CITY OF
West Linn

**STAFF REPORT
FOR THE HISTORIC REVIEW BOARD**

FILE NUMBER: DR-23-01

REQUEST: Provide a recommendation to the Planning Commission regarding a proposed Design Exception to exceed the maximum height limit of two stories, as part of a Class II Design Review at 1919 & 1949 Willamette Falls Drive.

2 SECOND FLOOR PLAN + EAST & 12th STREET ELEVATIONS

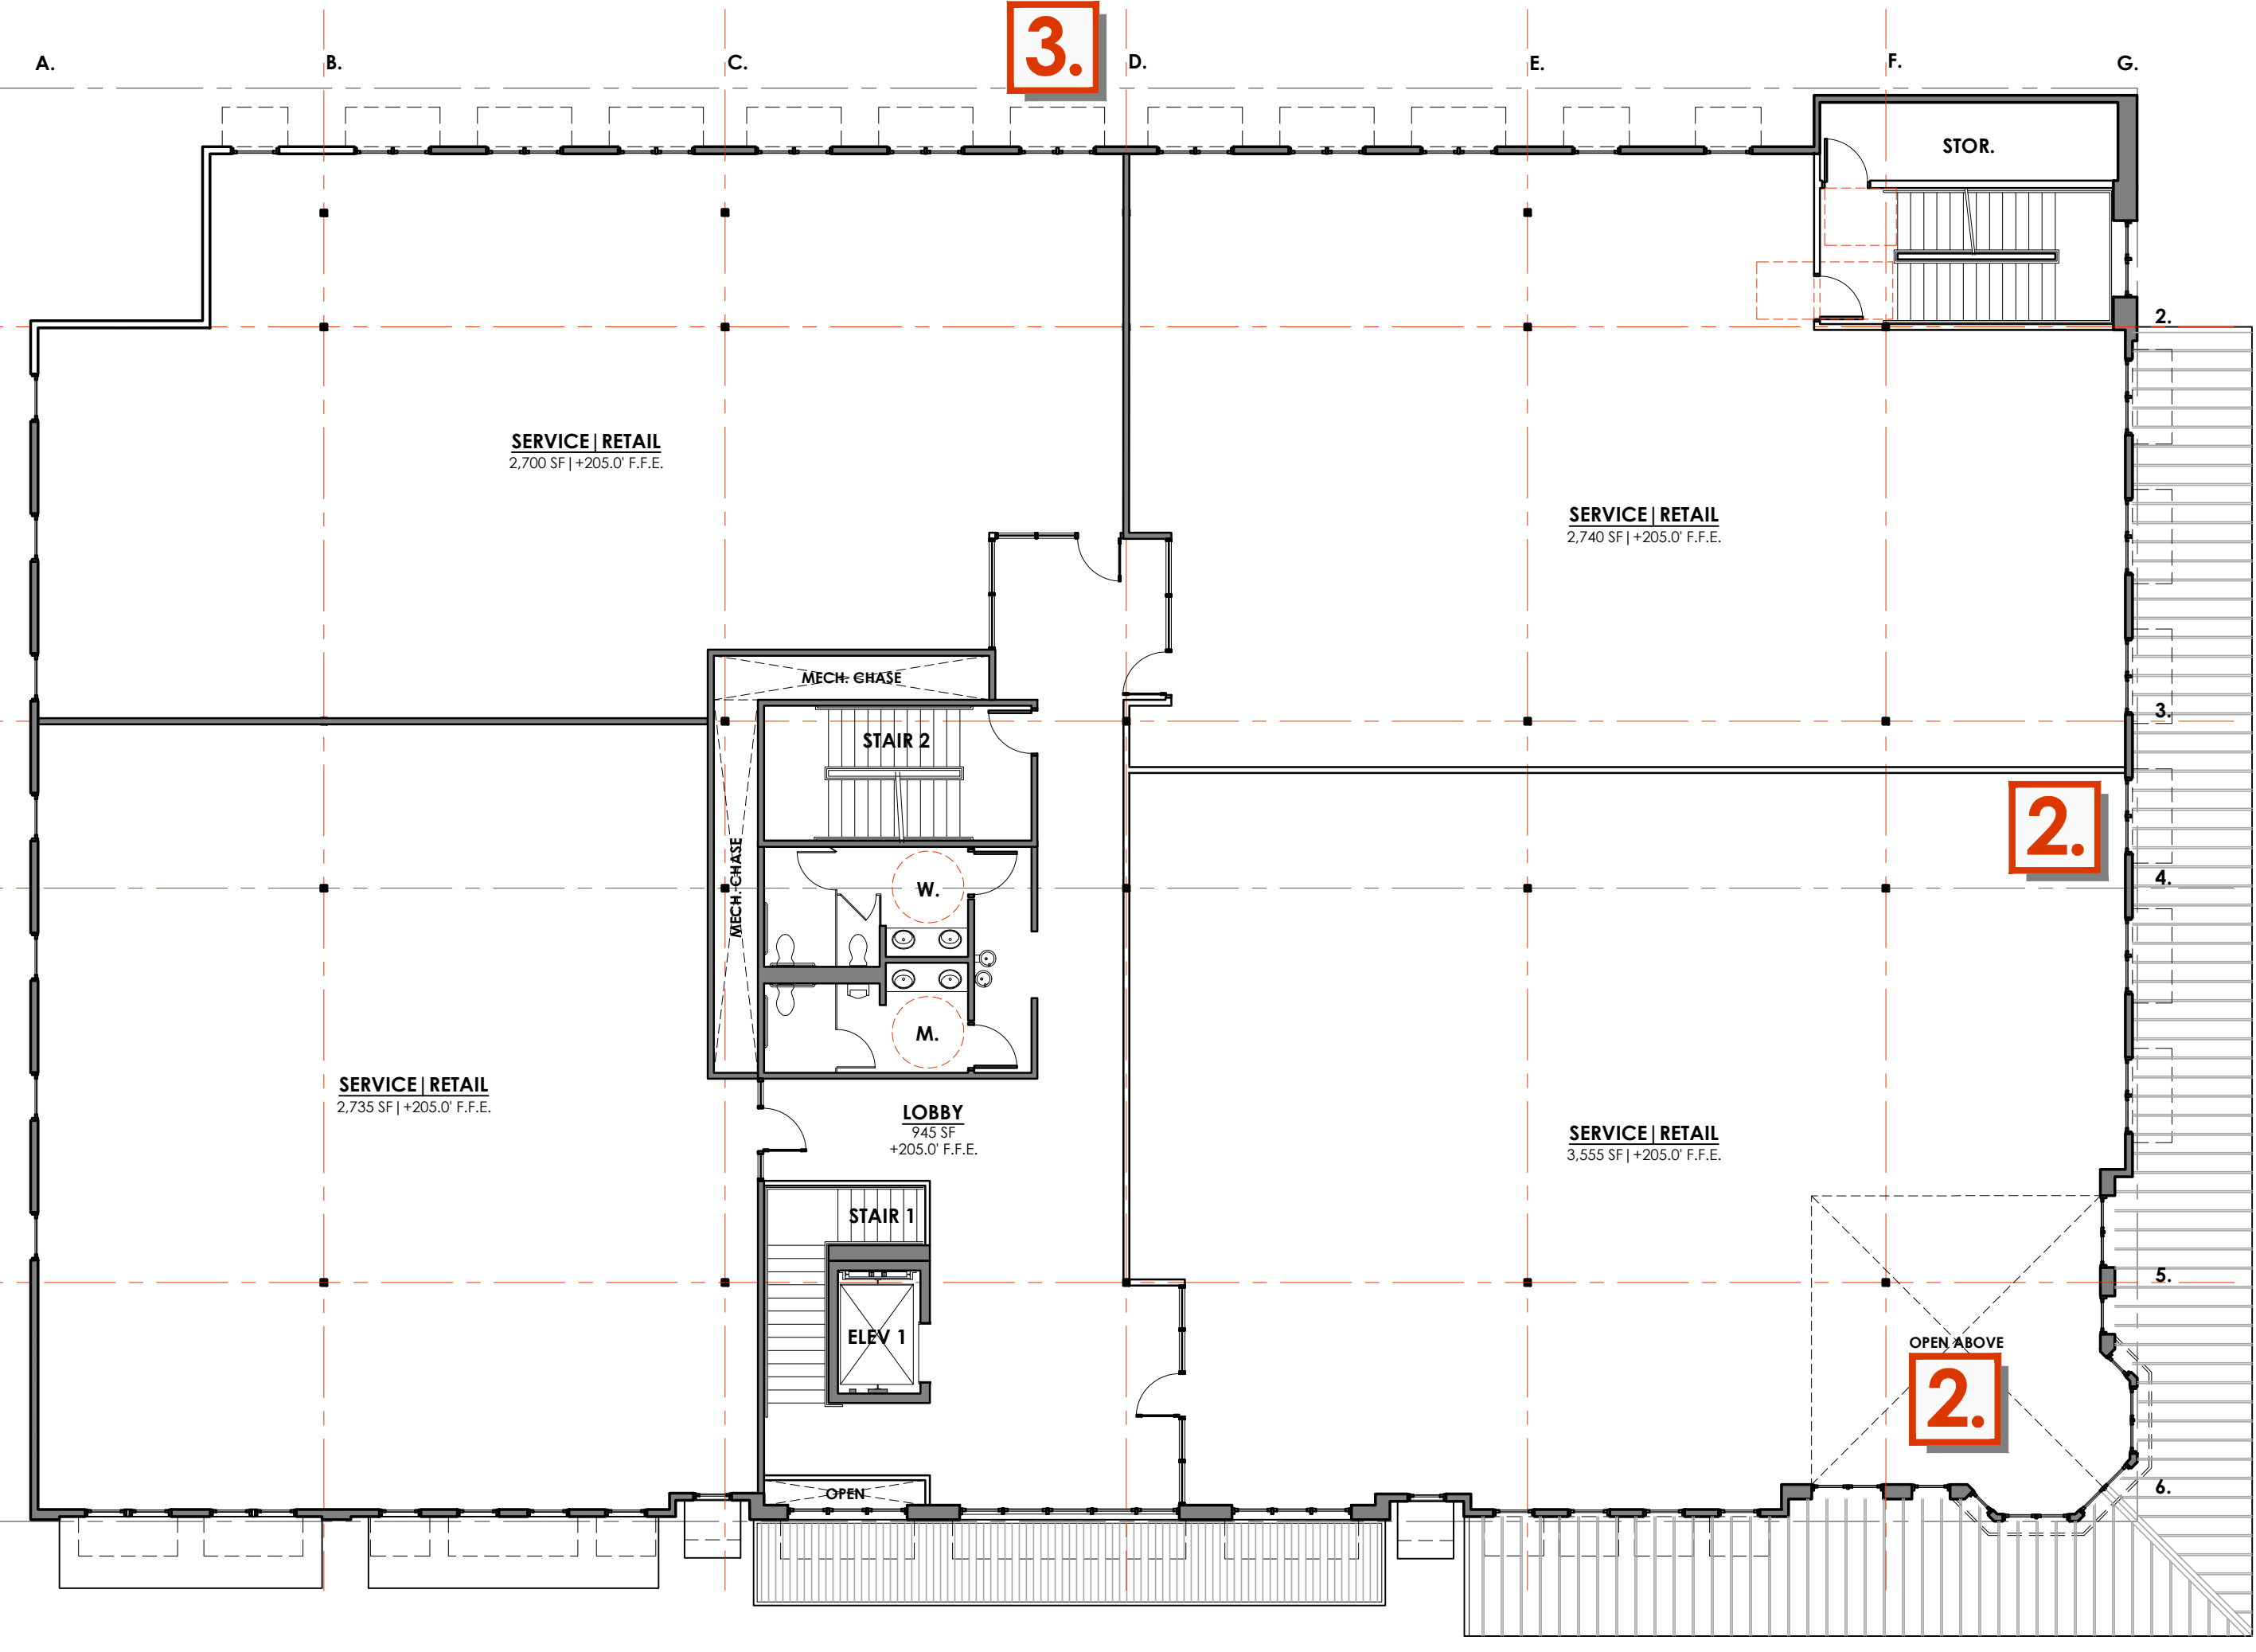
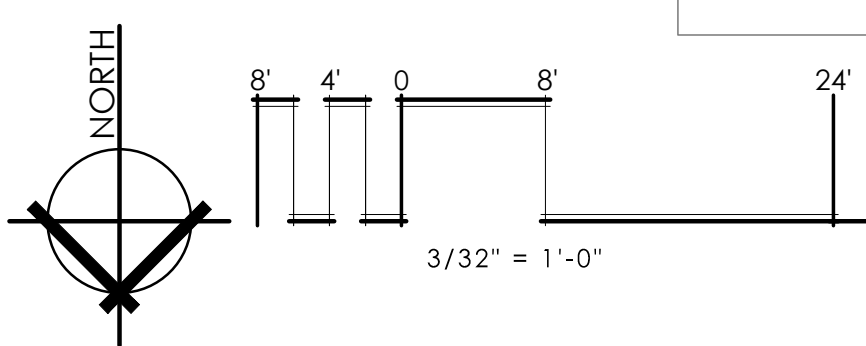
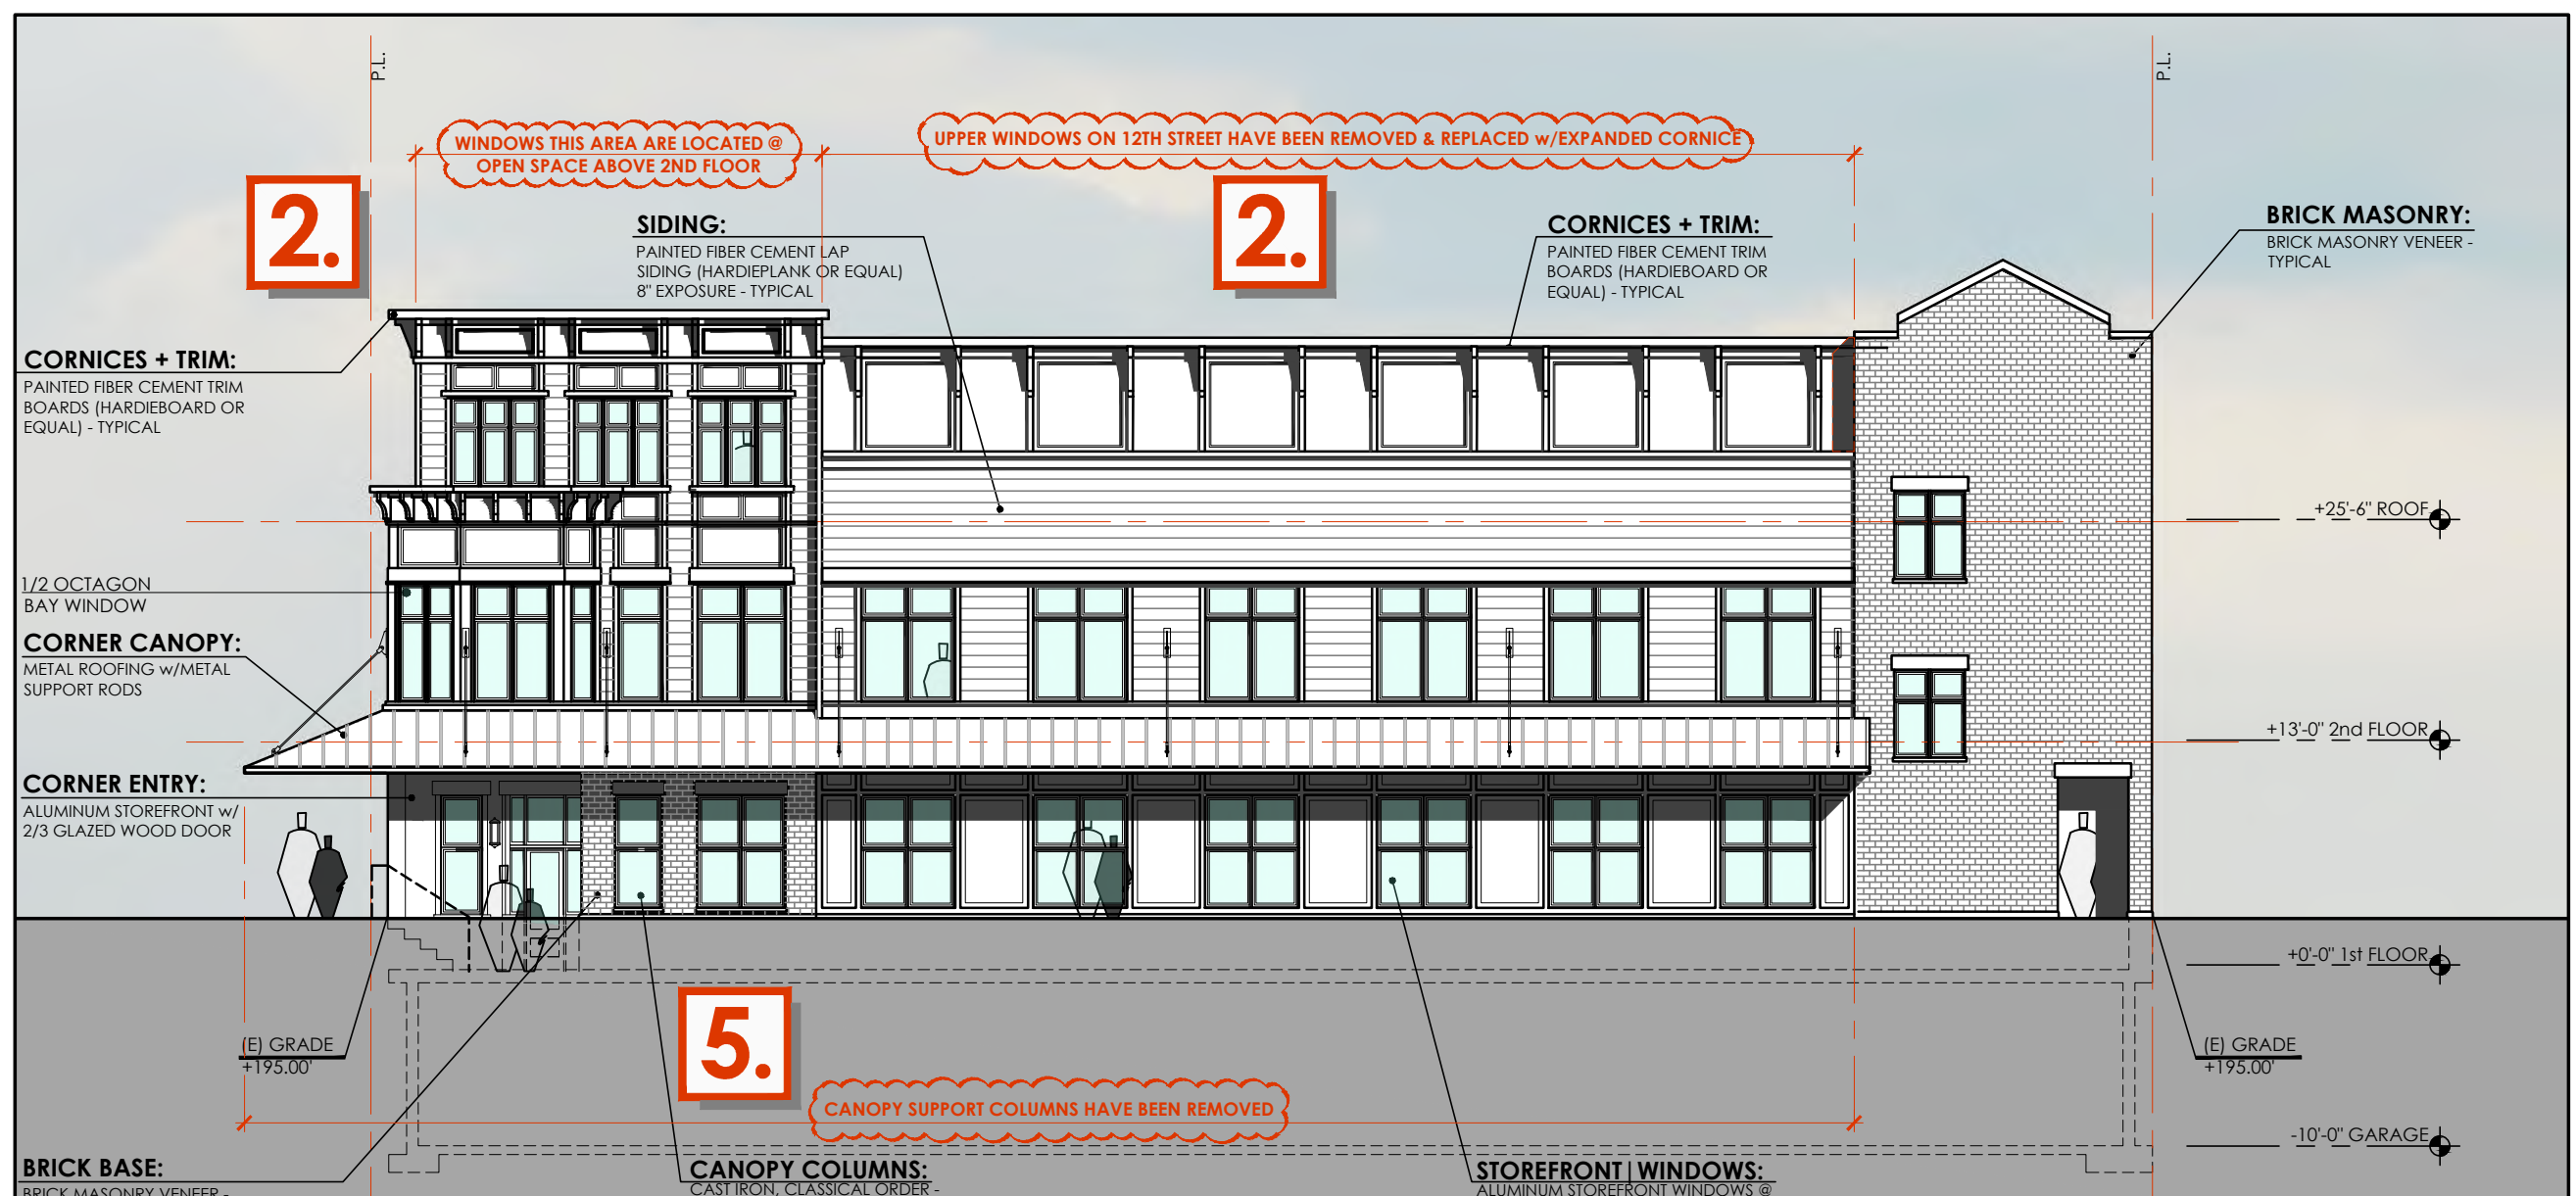
1. THE ENCLOSED ROOFTOP SPACE WAS RE-PURPOSED FROM LOUNGE TO BUILDING STORAGE, AND THE RESTROOMS AND WESTERN ELEVATOR DELETED. AN HVAC EQUIPMENT SPACE WAS ADDED NEAR THE REMAINING ELEVATOR. BOTH SPACES WILL ALSO BE UNOCCUPIED AND UNCONDITIONED. THE OUTDOOR ROOF DECK REMAINS FOR GENERAL USE BY TENANTS AND GUESTS.

2. THE WINDOWS ALONG 12th STREET WERE REMOVED AND REPLACED WITH A REDESIGNED CORNICE, PAINTED PANELS, AND PAINTED VERTICAL PILASTERS, BREAKING UP THE FACADE INTO VERTICAL COMPONENTS. WINDOWS REMAIN AT THE CORNER AS A CLERESTORY TO THE SECOND FLOOR.

3. THE WINDOWS ON THE KNAPPS ALLEY ELEVATION WERE RE-DESIGNED TO MATCH THE SIZE AND SPACING OF THE SAME 1969 WFD ELEVATION. THESE WERE DEEMED ACCEPTABLE DURING THAT BUILDING'S HRB AND PLANNING COMMISSION REVIEWS.

4. PER CHAPTER 58, THE 35' HEIGHT LIMIT OCCURS MIDWAY BETWEEN EAVE AND TOP OF PARAPET (WITHOUT A GABLE, THE FLAT ROOF LINE SERVES AS THE EAVE). PER CHAPTER 41, HEIGHT IS MEASURED AT GRADE, 5' FROM THE FRONT ELEVATION. A HEAVY DASHED RED LINE SHOWS THE 35' HEIGHT ON THE WFD ELEVATION. A SECOND RED LINE WAS ADDED, INDICATING THE FLAT ROOF/EAVE BEHIND THE PARAPET.

5. THE CANOPY SUPPORT COLUMNS HAVE BEEN ELIMINATED. THE CANOPY WILL BE SUPPORTED BY TIE-BACK RODS MATCHING THOSE APPROVED ON THE 1969 WFD BUILDING.

SUBMISSION FOR REMAND TO HRB: DESIGN EXCEPTION

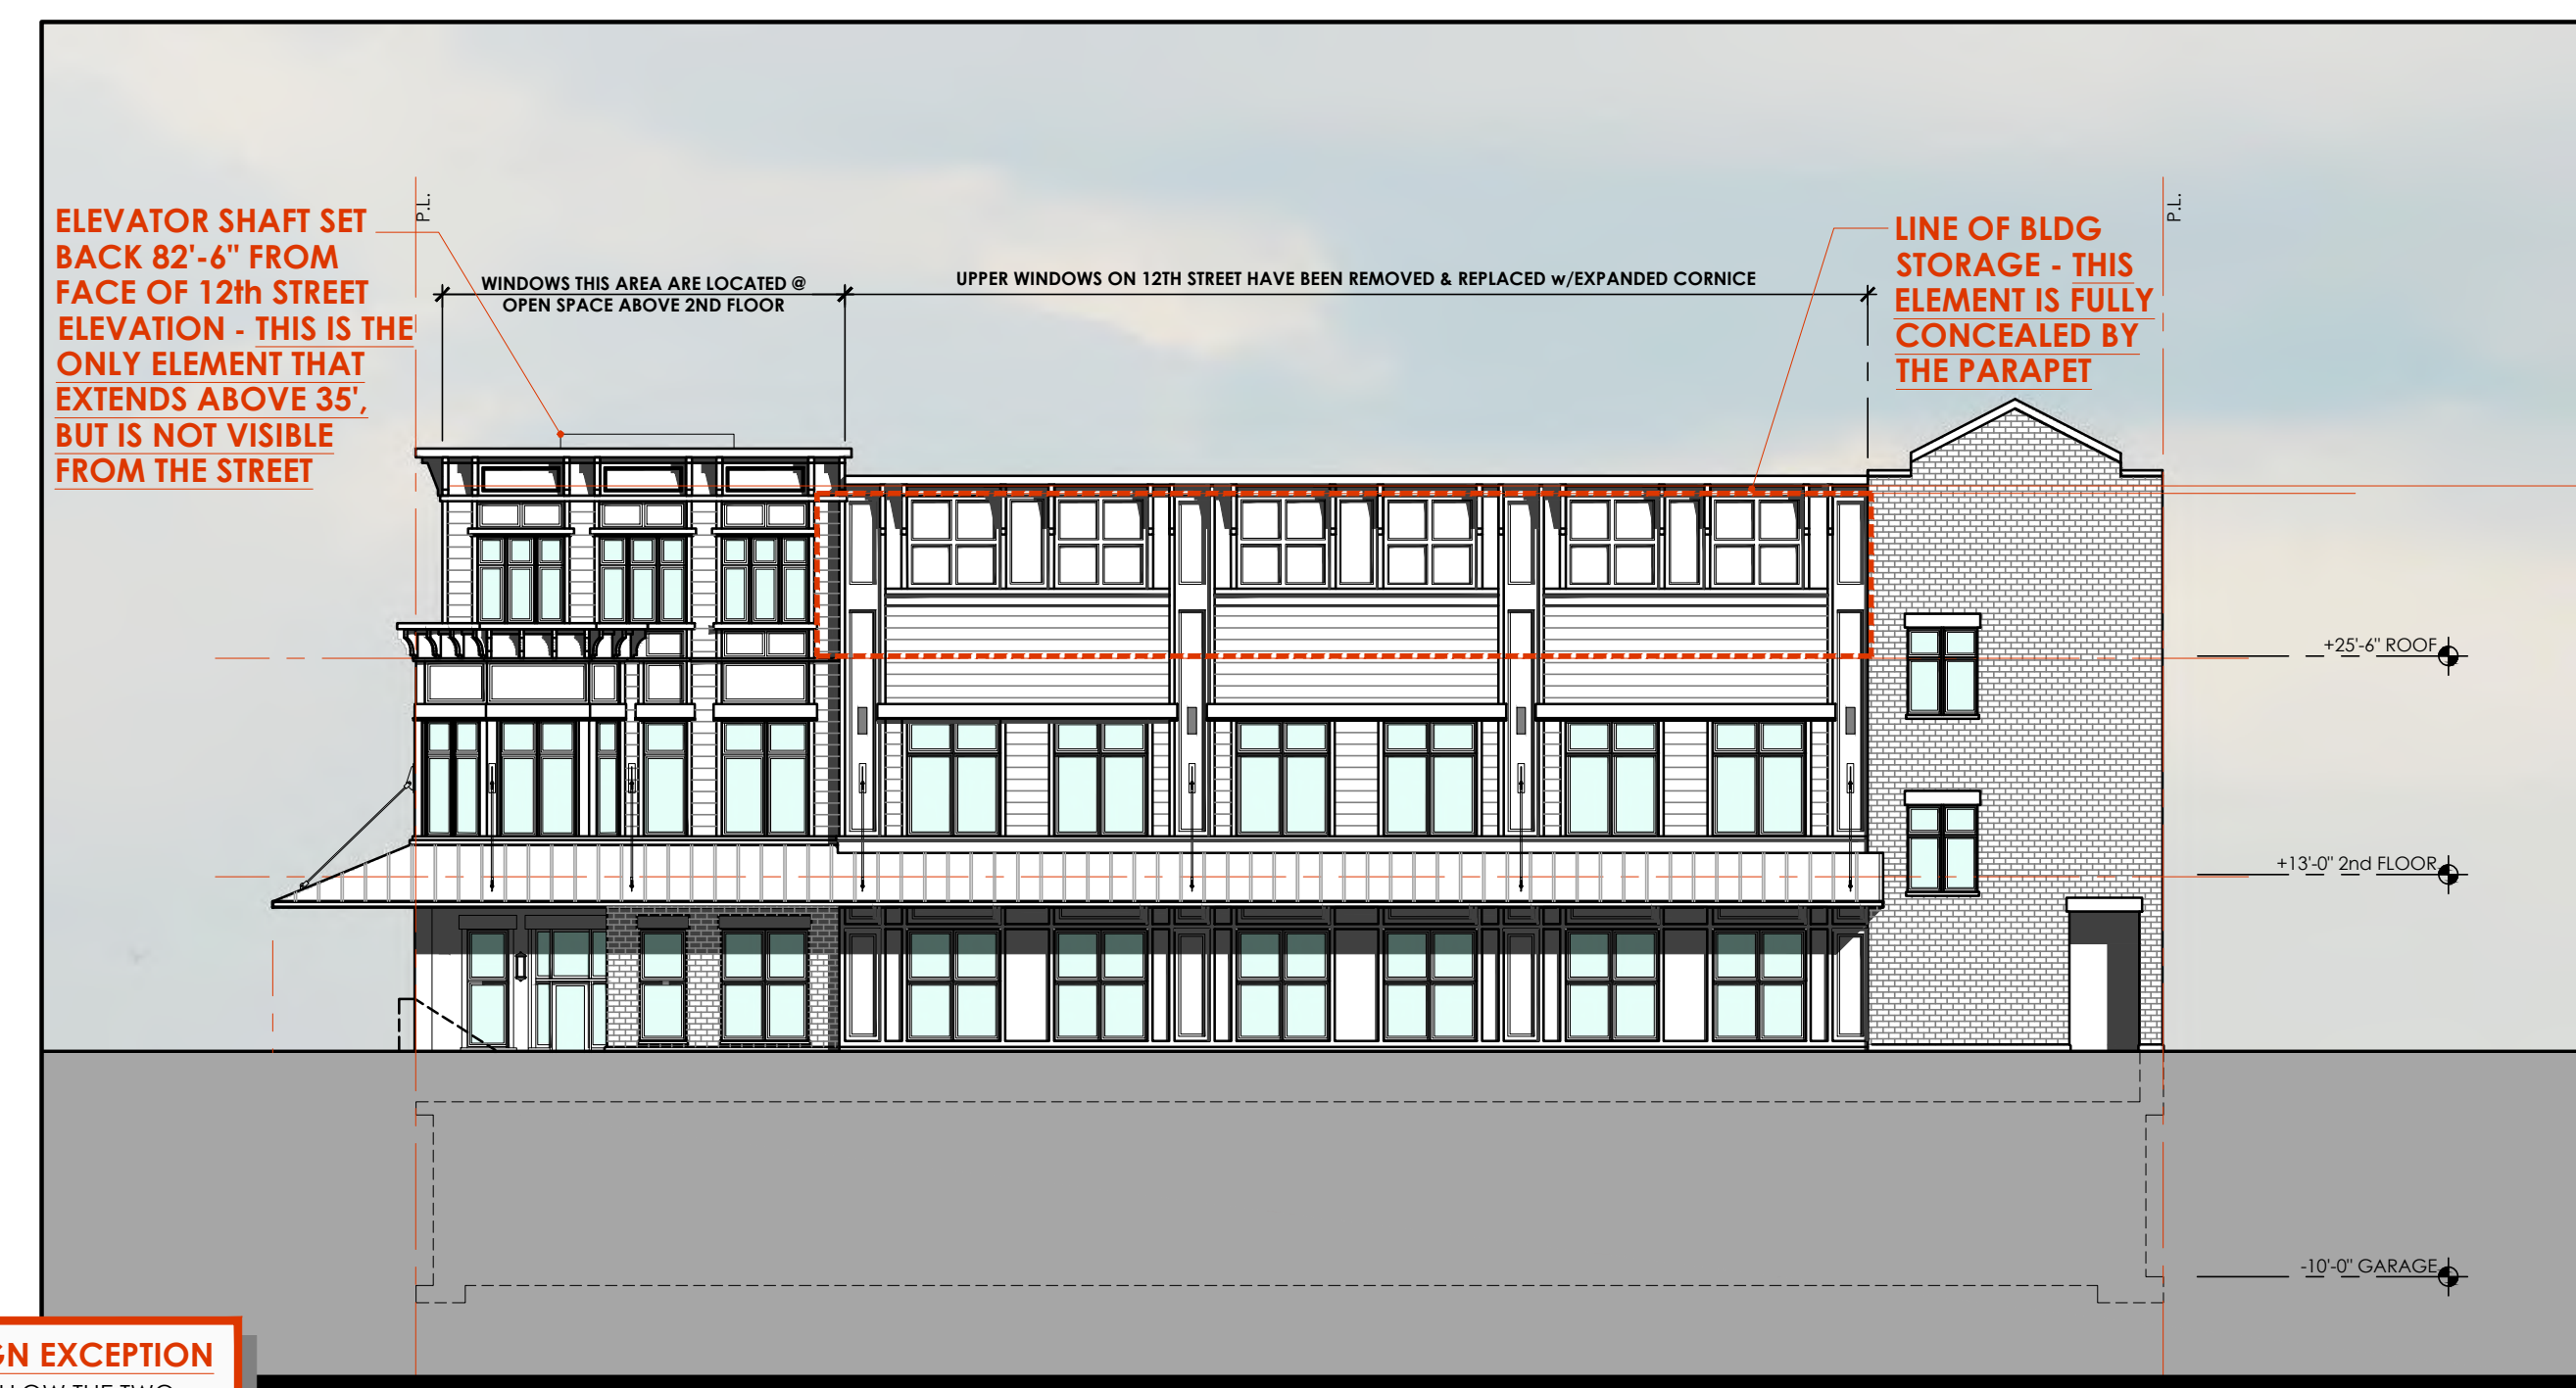
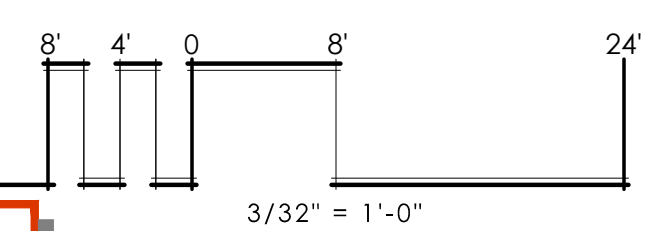
1. WE ARE PROPOSING A DESIGN EXCEPTION TO ALLOW THE TWO ROOF TOP SPACES SHOWN ON THE ROOF PLAN; ONE FOR HOUSING BUILDING HVAC SYSTEMS AND ONE FOR CRITICALLY NEEDED BUILDING STORAGE. THEY SERVE ONLY AS SUPPORT SPACES AND WILL BE UN-OCCUPIED AND UN-CONDITIONED.

4. SMALL PORTIONS OF THE PROPOSED ROOF TOP SPACES ARE VISIBLE IN 2D ELEVATION VIEWS. THE TOP OF THE ELEVATOR SHAFT IS ALSO VISIBLE, BUT THAT IS EXPRESSLY ALLOWED UNDER CHAPTER 41 AND DOES NOT REQUIRE A DESIGN EXCEPTION.

5. HOWEVER, A 2D ELEVATION VIEW DOES NOT REPRESENT WHAT CAN BE SEEN AT STREET LEVEL. WE HAVE INCLUDED SECTIONS SHOWING THAT THE PROPOSED ROOFTOP SPACES ARE NOT VISIBLE FROM WFD, 12th STREET, OR KNAPPS ALLEY - NOR EVEN FROM THE SECOND STORIES ACROSS KNAPPS ALLEY AND WFD.
